<b>SERVICE LETTER NUMBER 156</b>			
<b>TITLE: PLUGGED BULKHEAD SEALANT REMOVAL</b>			
BY: M.DILLON	AIRCRAFT MAKE/MODEL(S):	FLOAT MODEL(S):	NOTE(S):
APP: C.WOKEN	Quest Kodiak 100	7000	MANDATORY COMPLIANCE
DATE: 03/19/14	Cessna 208 Series	8750	<b>S/L P/N 1008025</b>
REV: A	Cessna 208B Series		<b>ECO- 23612</b>

AREA AFTER REMOVAL OF  
SEALANT AND PRIMER  
RE-APPLIED

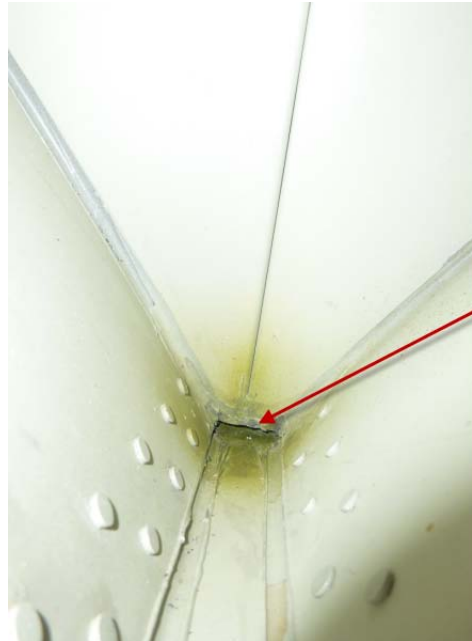
2. Inspect partial bulkheads (8750- #3, 6, 8 or 7000- #3, 5, 8) located in the middle of the compartments to confirm whether there is a complete seal between the bulkhead and main keel that will prevent water from flowing through to the pump-out tube. If there is no opening, proceed to Step 3.

3. Using an awl, perforate the existing sealant and work it loose. Use a small scraper or blade to remove the fragments until there is a clear area of approximately  $\frac{1}{4}$ " between the bulkhead and main keel to allow water to pass through.  
**NOTE: Use caution when removing sealant to avoid scraping or chipping the primer.**
4. Remove all sealant debris from float compartment.

5. If the primer was scraped in the removal process, re-prime the areas of bare metal after the sealant is removed.
